<p>VOLLMER DRAINAGE IMPROVEMENTS 115 KV LAYOUT, GRADING, & DRAINAGE DETAILS TRI-STATE GENERATION & TRANSMISSION ASSOCIATION, INCORPORATED</p>	7	NO.	DATE	APPD.	REV.	M.F.
	6					
	5					
	4					
	3					
2						
1

S1150-A-01-011

ORIFICE PLATE AND TRASH RACK DETAILS AND NOTES

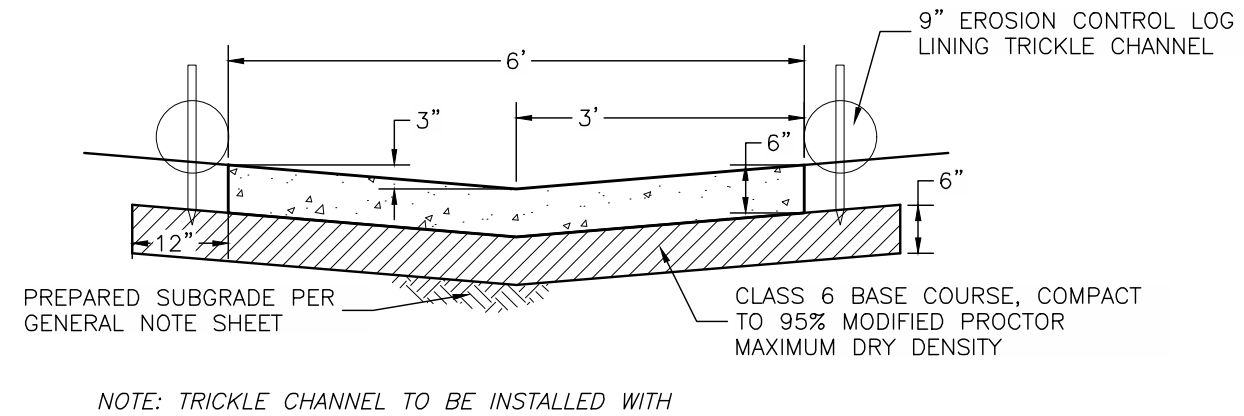
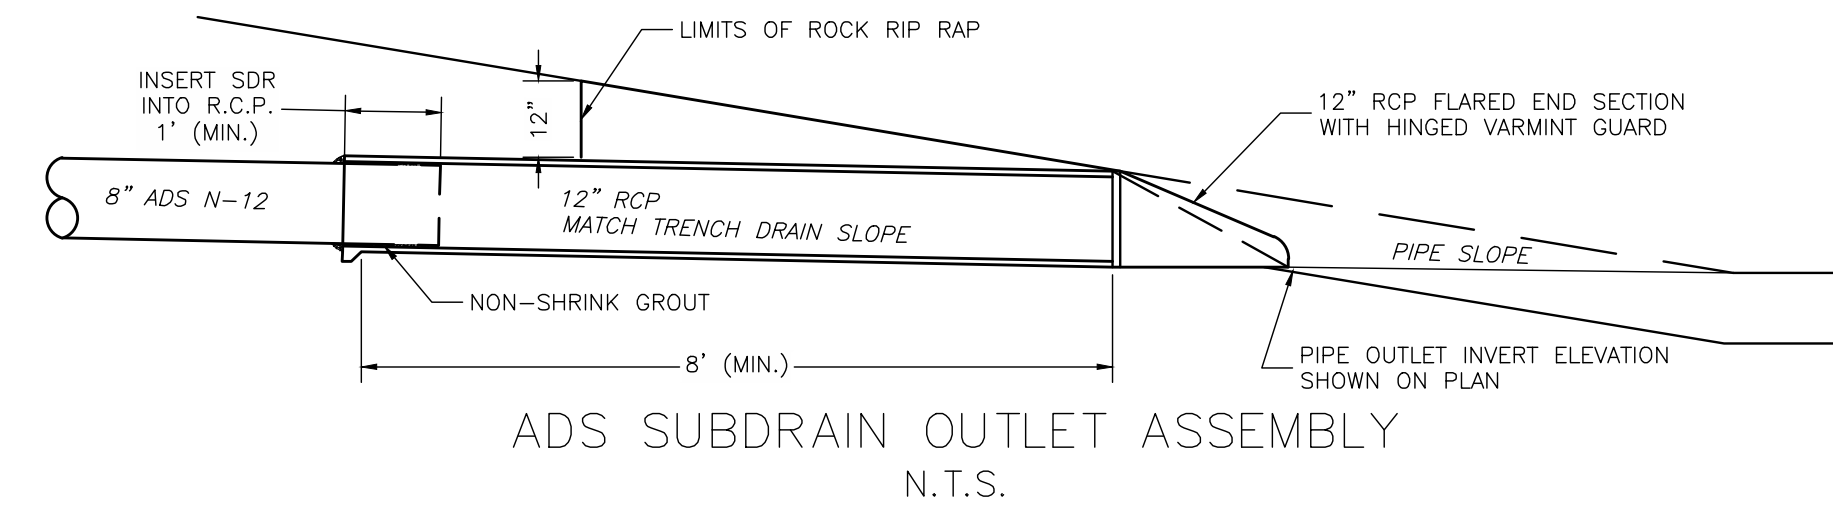
A spillway is necessary to direct overflows. If this is where you'd like the spillway (to direct flows to where the pond outlet pipe outfalls to ditch), then you could do an armored Texas crossing here to lower the road enough to get the desired spillway elevation. But obviously make sure that you maintain sufficient cover on the existing pipe.

Pond bottom should have a minimum slope of 3% to the trickle channel and micropool (USDCM Vol 3, detail T-5). Please adjust to minimize future maintenance needs.

Do you mind assign a name/number to this EDB? If you do, just make sure to update all submitted text and drawings accordingly with consistent labeling throughout (example: "Pond A" or "Pond 1"). These labels just help us out with post-construction inspections and tracking in our database/GIS.

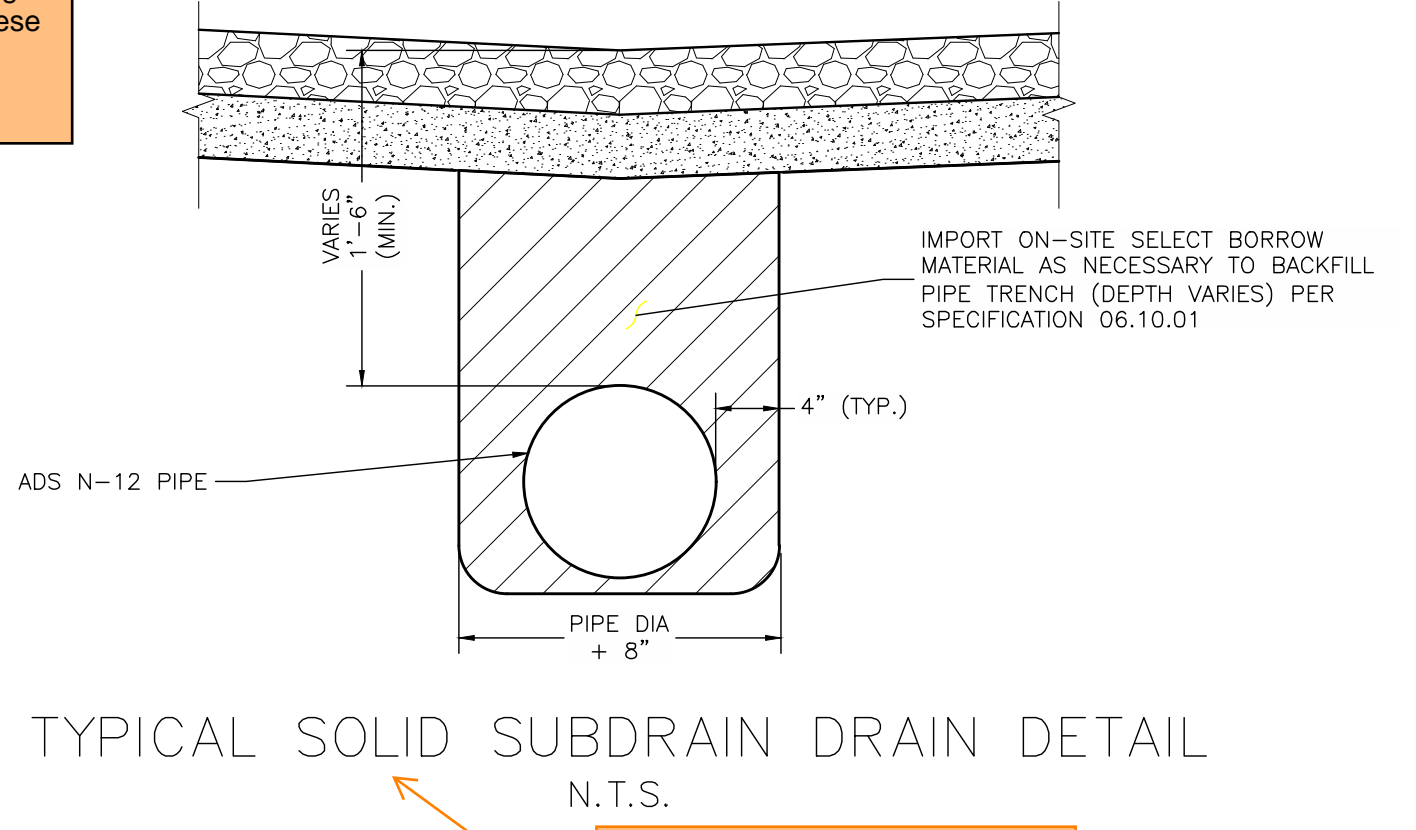
Note that we encourage instead using a flat bottomed trickle channel for ease of maintenance, unless you have a means of easily removing sediment from a V-shaped channel.

TYPICAL PERFORATED SUBDRAIN DETAIL
N.T.S.

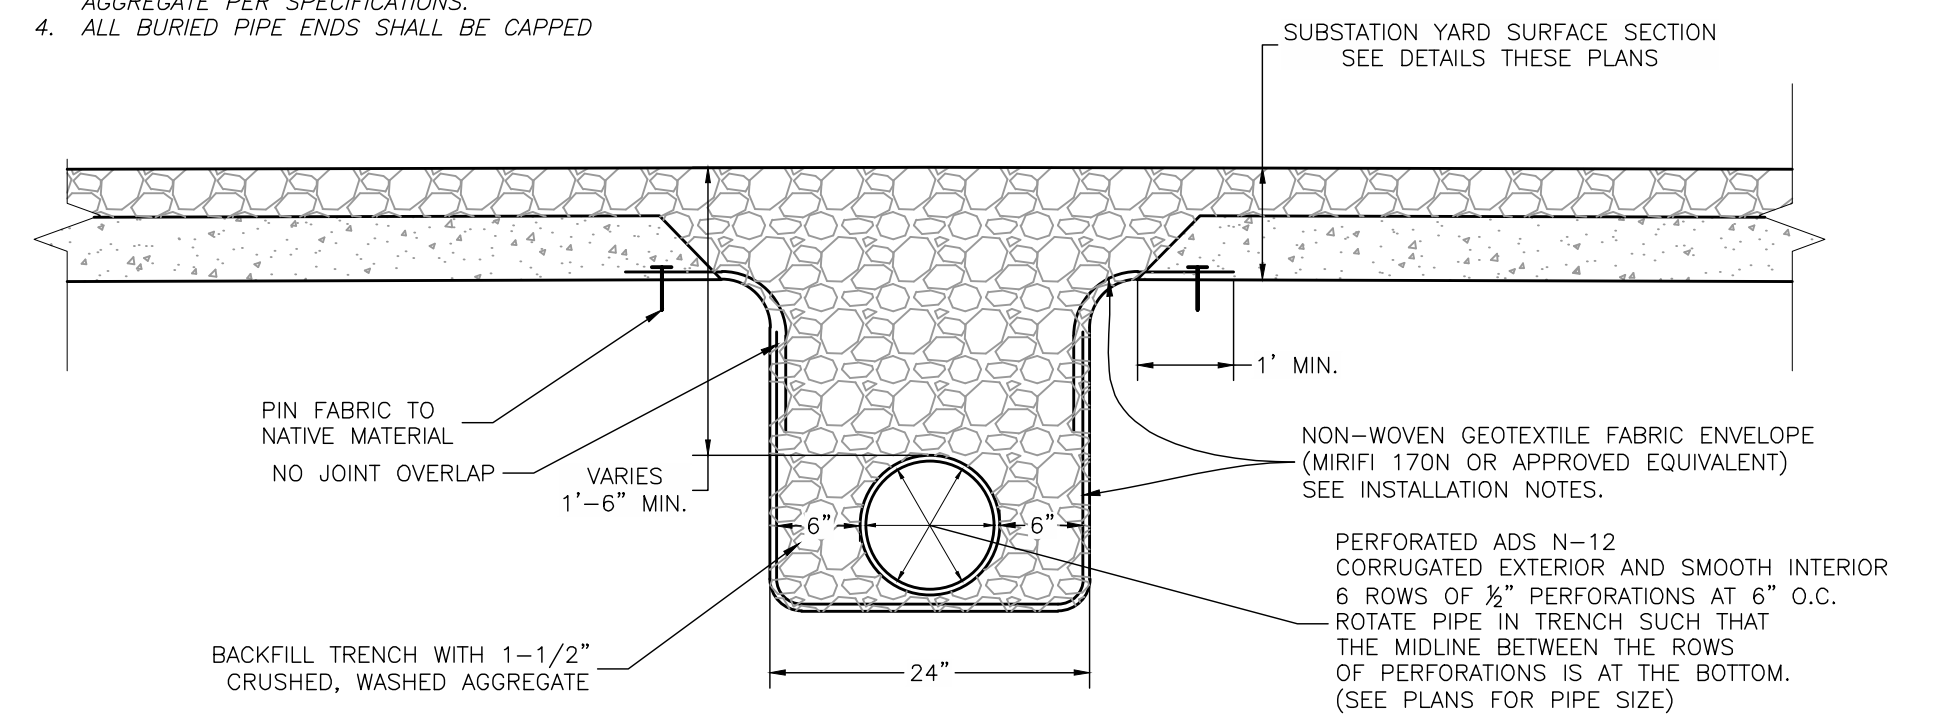
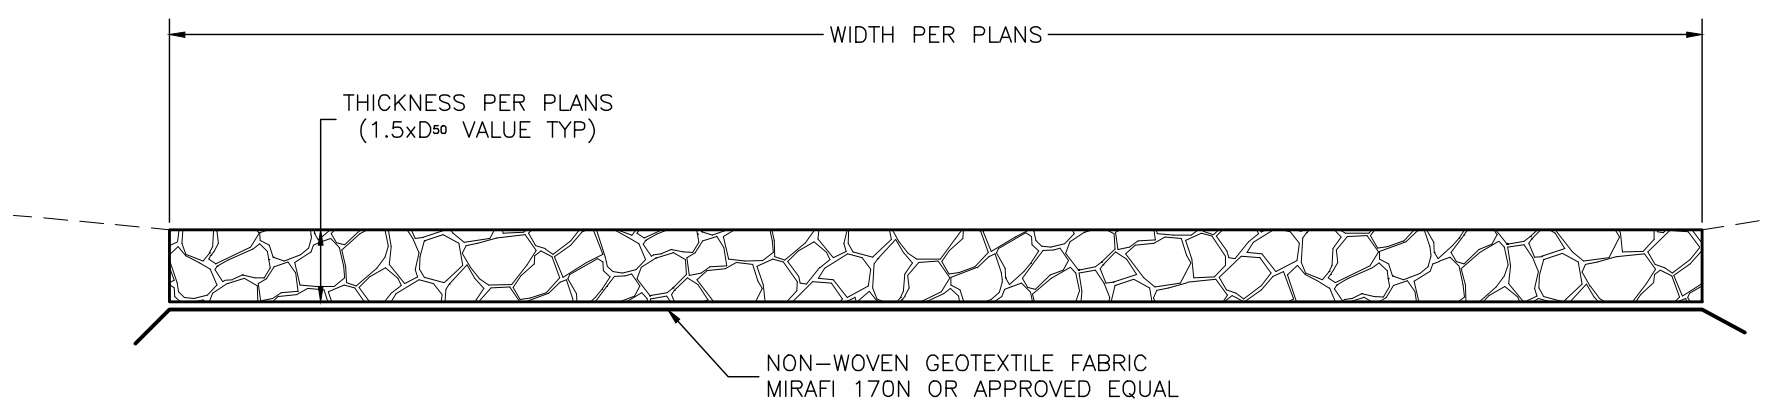
All perforated subdrains on plans appear to be labeled as perforated. If this is accurate, please delete this solid pipe detail to avoid confusion.
